**GROWTH MANAGEMENT DEPARTMENT STAFF REPORT**  
**VILANO BEACH TOWN CENTER OVERLAY DISTRICT**  
**February 9, 2022 Public Meeting**  
**VBTCDR 2021-06 Ocean View Lodge Expansion**

**To:** North Coastal Design Review Board  
**Staff:** Teresa Bishop, AICP, Planning Division Manager  
**Date:** January 24, 2022

**Summary of Request:** The applicant requests design approval for an expansion of the existing Ocean View Lodge. The expansion includes 12 hotel rooms within a 5,928 total square foot addition.

Architectural Review Comments  
Vilano Beach Town Center  
Ocean View Lodge Expansion

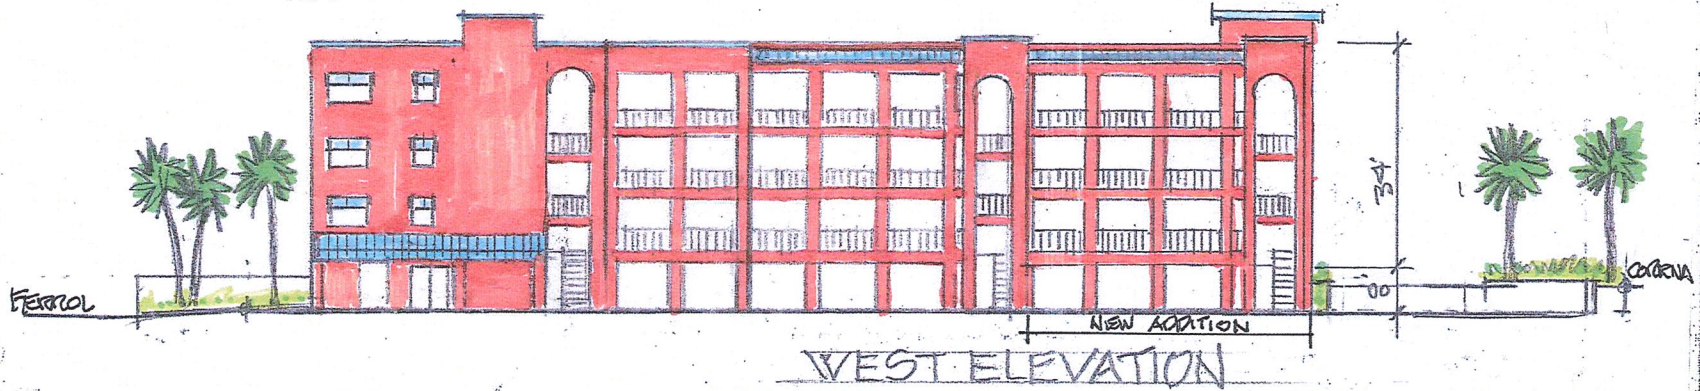
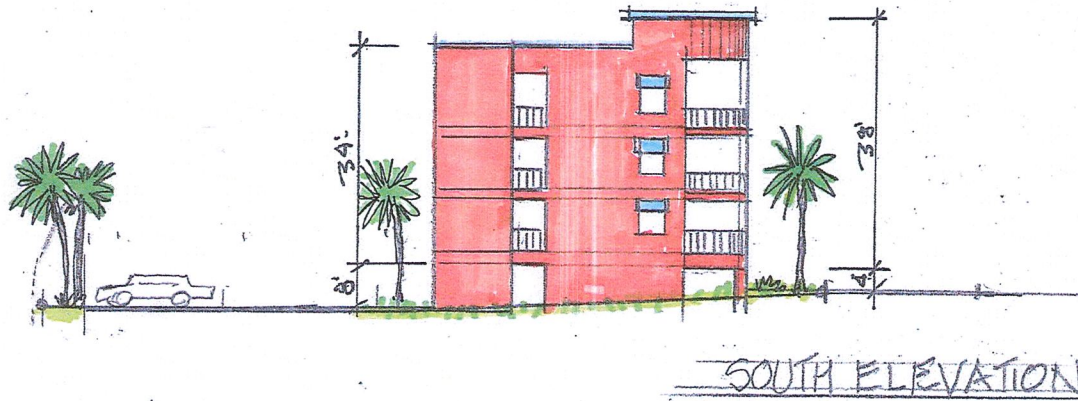
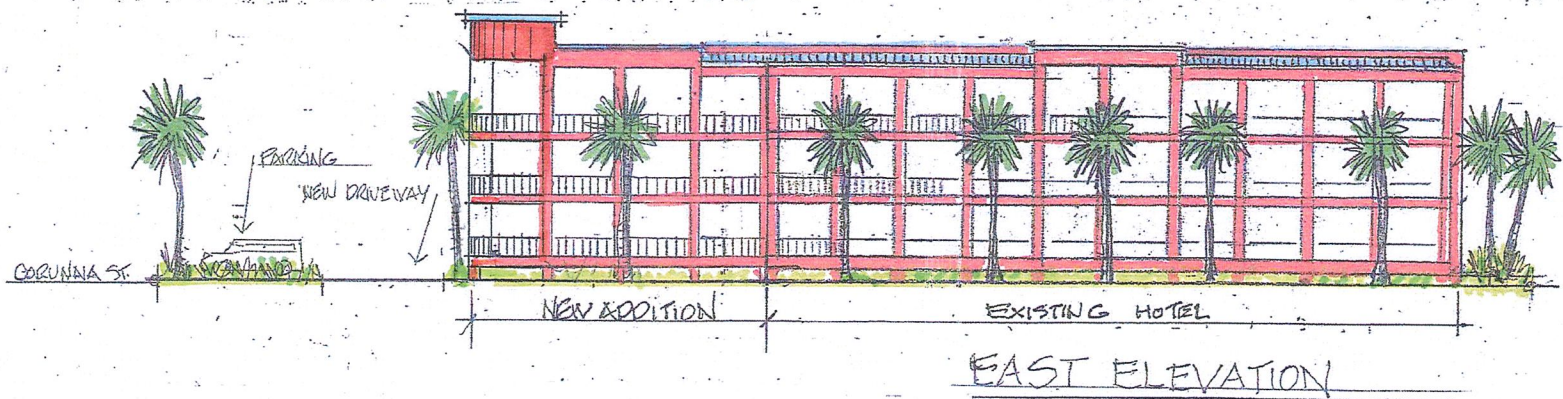
The proposed addition is consistent in design and scale with the existing hotel.

The proposed addition is consistent in height with the existing hotel. Fenestration (windows, porches, arcades, loggias and balconies) are comparable with the existing hotel. The addition is an extension of the existing hotel and is oriented with the north-south axis of the existing building.

The exterior finish of the addition is stucco which is consistent with the existing hotel.

The exterior color proposed for the new addition matches the color of the existing hotel.

The doors and windows proposed for the new addition are consistent with the existing hotel.

The proposed balconies and porches are an extension of the existing hotel and are compatible. The balcony railings are the same height, color and style as that of the existing hotel.

The proposed new addition's roof is flat which is consistent with the existing hotel. It is proposed to be the same height as the existing.

No information was presented on the proposed lighting for the new addition.

This application proposes an addition to the southern end of the existing Ocean View Lodge. The addition proposed is 3 stories in height with an exterior stairwell on the southern end. Although, as mentioned before, the design of the existing hotel is not consistent with the Town Center Design Guidelines, the addition is consistent with the existing hotel in all the elements referenced in this report. The designer has chosen to round the southeastern corner of the new addition which is the only curvilinear feature on the building. This rounded element is reminiscent of the Art Moderne style and may be intended to add an Art Moderne feature to the building.

CONCEPT SITE PLAN - 1

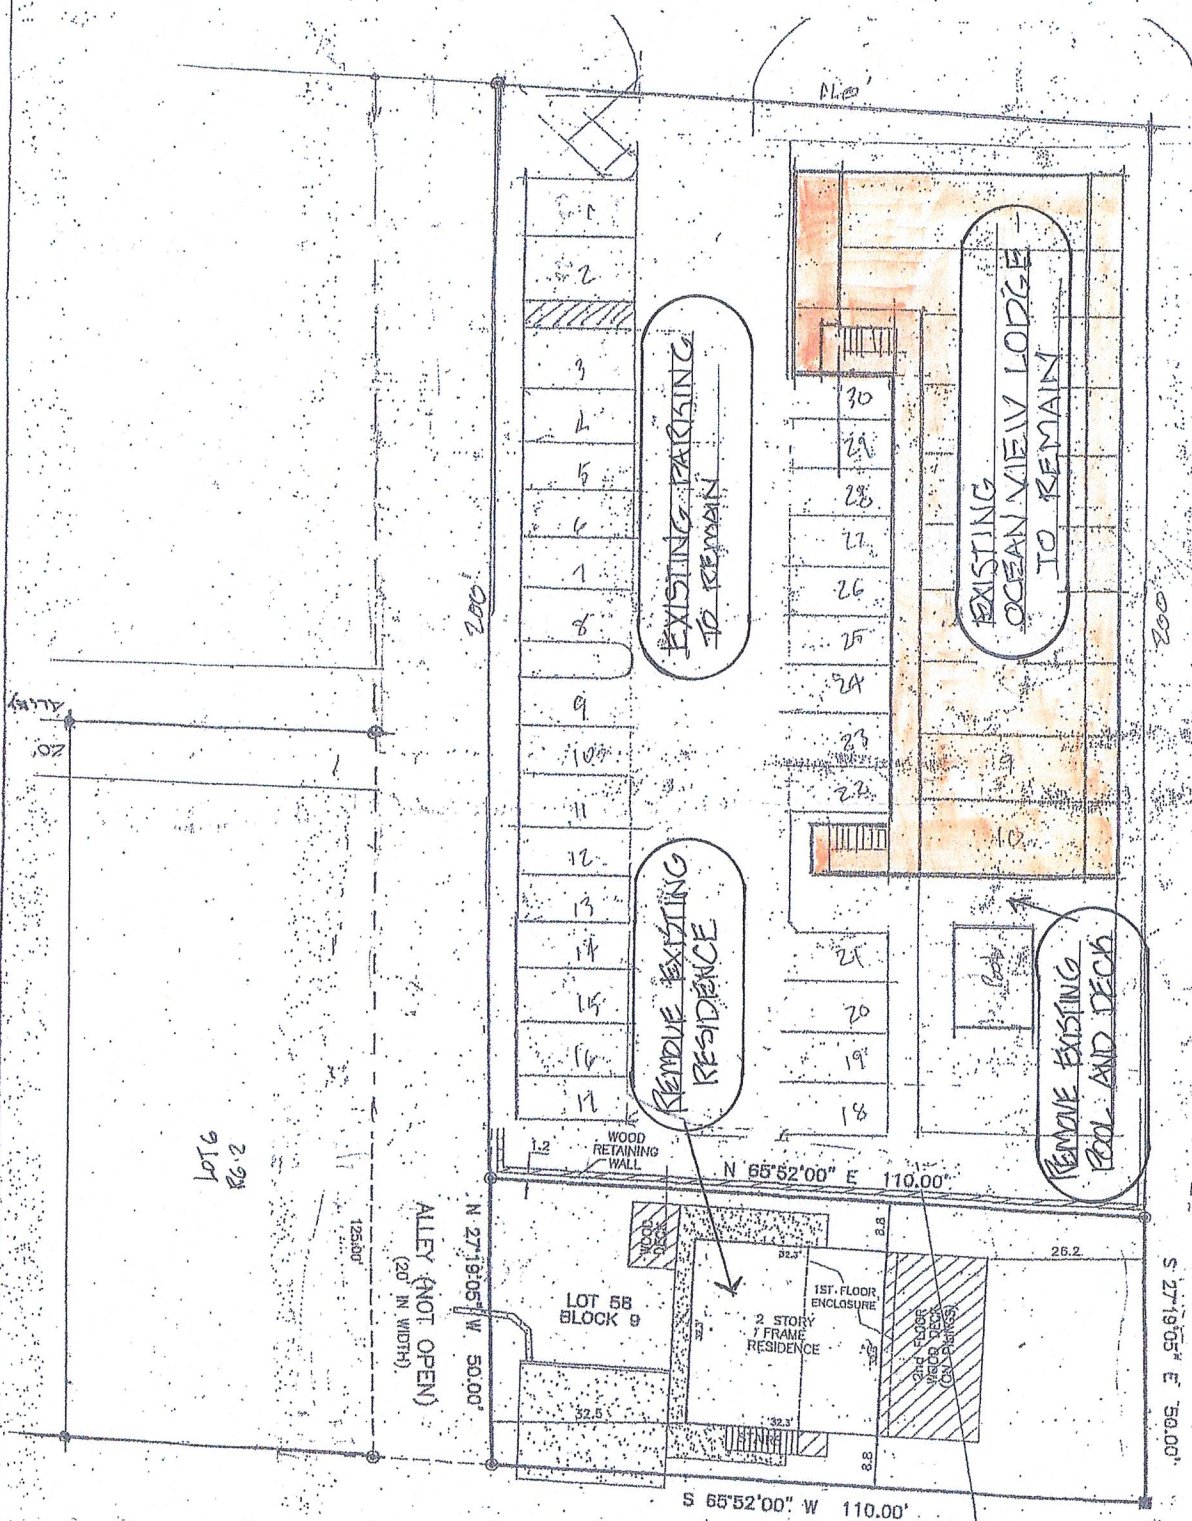
Section 3.10.04.A.9. Transmission, phone and cable boxes will be placed in the rear of the development and decorated in a manner compatible with the architectural style of the building. These utility elements are not shown on the site plan. The DRB may want to ask the applicant to provide where such utility elements are located and how those are screened.

Section 3.10.05.J. Parking. Parking is proposed along Corunna Street. There are 40 parking spaces provided, including the existing and proposed. Parking will be reviewed with the construction plans.
